# CITY OF DAHLONEGA City Council Public Hearing Agenda

## CONSULTING PLANNER'S REPORT

**SUBJECT:** REZN 25-06 Rezoning from Planned Unit Development

(PUD) ("Buckhorn Development") to PUD ("The Overlook of

Site Plan Excerpt (proposed PUD)

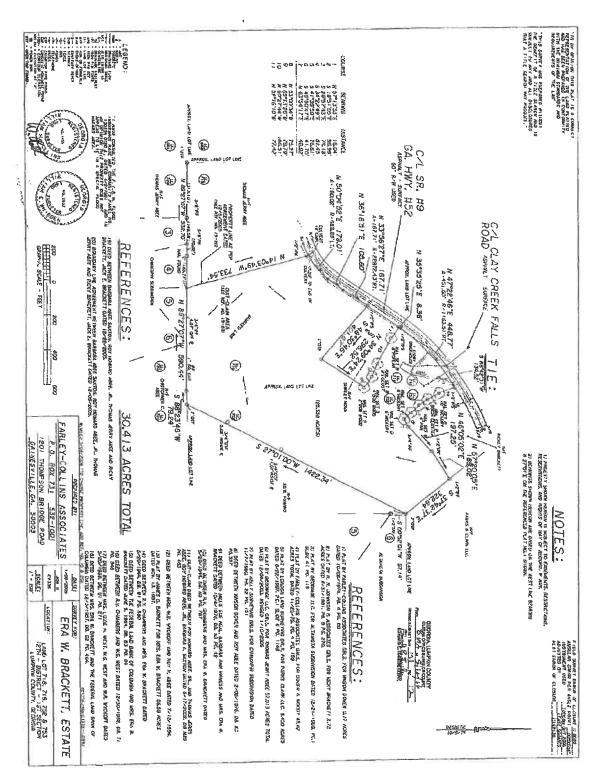
Finding: Generally, the PUD meets this criterion (*meets guideline*). There are only two cul-de-sacs proposed, and the road network is considered mostly interconnected. However, in the single-family residential portion of the PUD, the street lengths are long and would benefit from a mid-block pedestrian connection (*supports conditional approval*).

Finding: The proposed commercial area is 17,000 square feet on 2.17 acres. While the proposed commercial square footage exceeds the 10,000 square feet suggested, the proposal is not considered excessive. The acreage devoted to commercial use does not exceed 10 percent of the total site area (*meets guideline*). The commercial area is internally oriented, without a curb cut onto Dawsonville Highway (*meets guideline*).

- 7. **Frontage for internal open space.** There shall be at least 30 feet of street access to the central open space (i.e., that area surrounded by townhouse lots).

- 9. **Street "A".** The principal street ("A") shall have a center median separating directions of travel, except for median cuts necessary to access adjacent land uses. Said center median shall be planted with street trees of species and at spacing/on-center intervals approved by the zoning administrator.

- (a) At least two pedestrian access ways between the townhouse building with units 1-7 and the townhouse building with units 22-27 (connecting to fire pit shown on the site plan).

- (b) At least three pedestrian access ways between townhouse buildings with units 34 through 68 (connecting to the peripheral walking trail).
  - (c) At least four pedestrian access ways connecting the central open space and street network between townhouse buildings with units 69 through 111.

- (d) At least two pedestrian access ways between townhouse buildings with units 112 through 136 (connecting to the peripheral walking trail).
  - (e) At least one pedestrian access way between single-family dwelling lots 1 through 10 (connecting the adjacent street to the peripheral walking trail).

- (i) One mid-block pedestrian access way connecting Road "B" (south) and Road "C" at or near the common side lot boundary between single-family lots 93-95 and 108-110.

- (j) One mid-block pedestrian access way connecting Road "B" (north) and Road "C" at or near the common side lot boundary of lots 77/78 and lots 63/64.
